CONTRACT CHANGE ORDER NO. ____
SHEET ___ OF ___

SAN FRANCISCO OAKLAND BAY BRIDGE
EAST SPAN SEISMIC SAFETY PROJECT
SELF-ANCHORED SUSPENSION BRIDGE
(SUPERSTRUCTURE & TOWER)

TYPICAL GIRDER DETAILS NO. 17B

ELEVATION AT UTILITY PIPE EXPANSION LOOPS (PP80-82 W5 Line Shown)

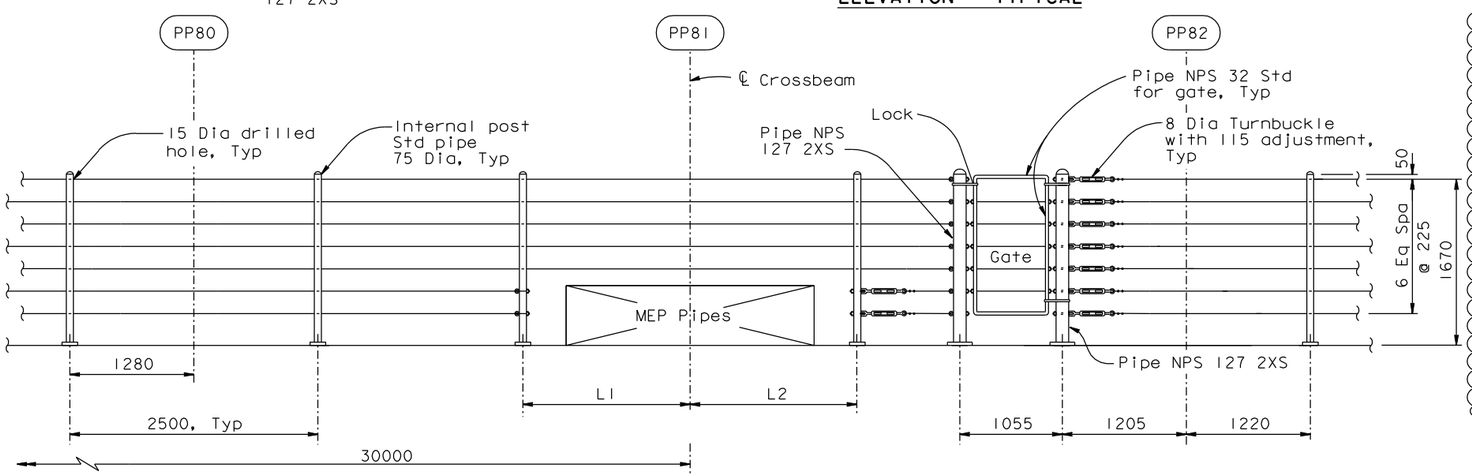
POST SPACING AT EXPANSION LOOPS			
PP	LINE	L1	L2
81	W5	1835	1835
81	E5	1685	1685
126	W5	2320	Eliminate post
126	E5	1885	1885
